**PRAIRIE ISLAND NUCLEAR GENERATING PLANT**  
Docket Nos. 50-282 License Nos. DPR-42  
50-306 DPR-60

**Response to NRC Questions Dated February 12, 2001**

### Prairie Island Response to NRC Follow-up Questions dated February 12, 2001 from the February 9, 2001 Meeting Regarding Unit 1 Steam Generator Eddy Current Test Results

**Figure 17**  
Eddy Current Data for Prairie Island R1C52

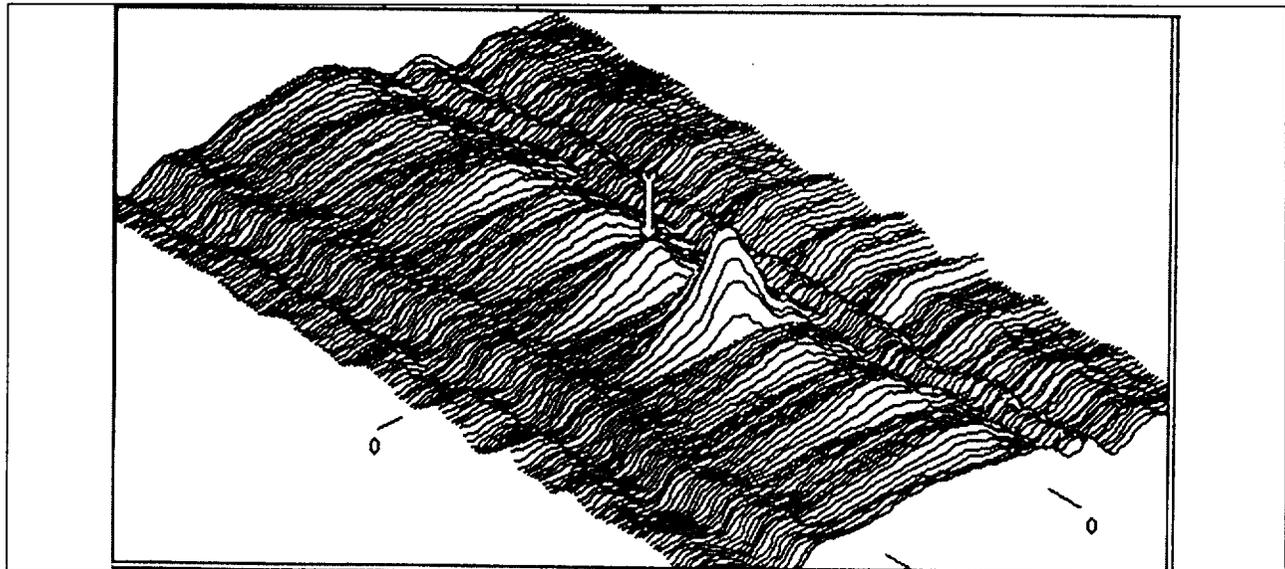
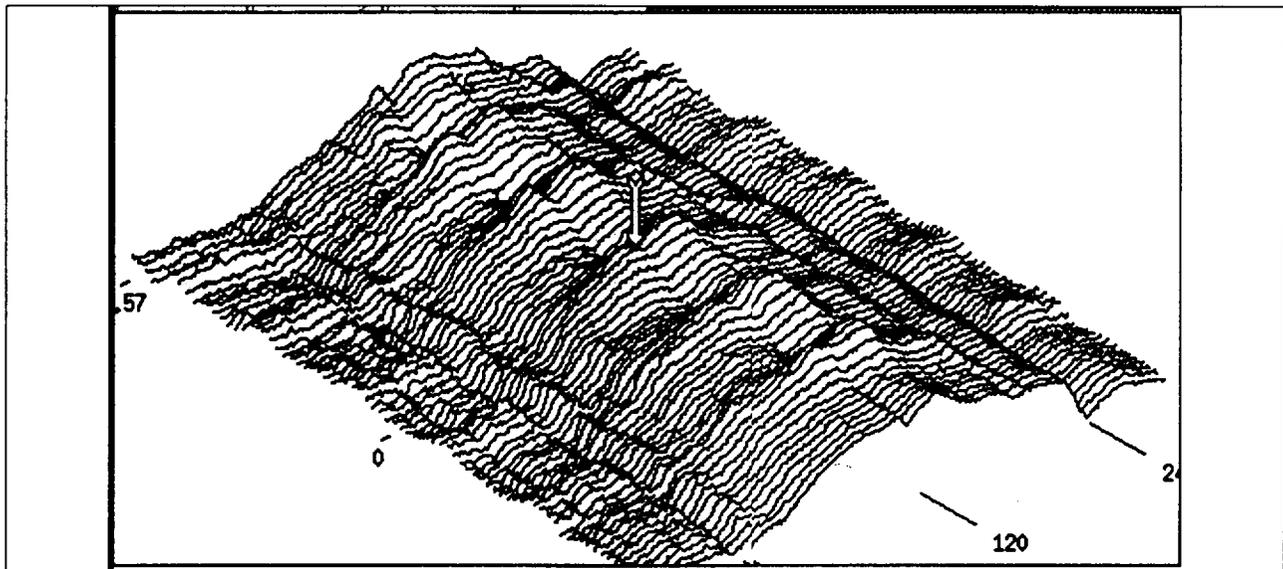
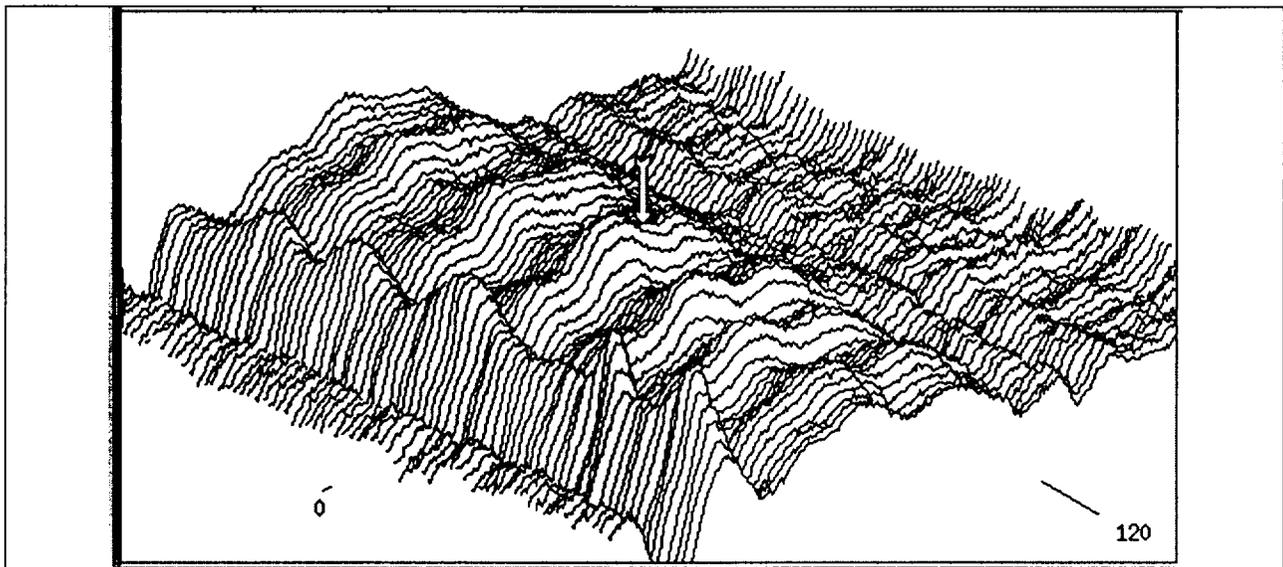
*Discuss how the data, analysis, and evaluations provided for the above questions can be used to support the acceptability of the steam generators at PINGP for the upcoming operating cycle.*

Figure 17 shows Prairie Island R1C52 eddy current data. Figures 18 and 19 show the eddy current c-scan of an EPRI U-bend qualification data set with horizontal ridges similar to R1C52. Thus, the horizontal ridges are not unique nor is a circumferential indication on the intradose of row 1 U-bend in the region between the two tangents. It is postulated that high stresses from the tube bending process physically change the intradose and the primary water stress corrosion cracks grow until high residual stresses are relieved. The ridges are due to the bending process.

There is essentially no growth in R1C52 when evaluating previous RPC data back to 1991.
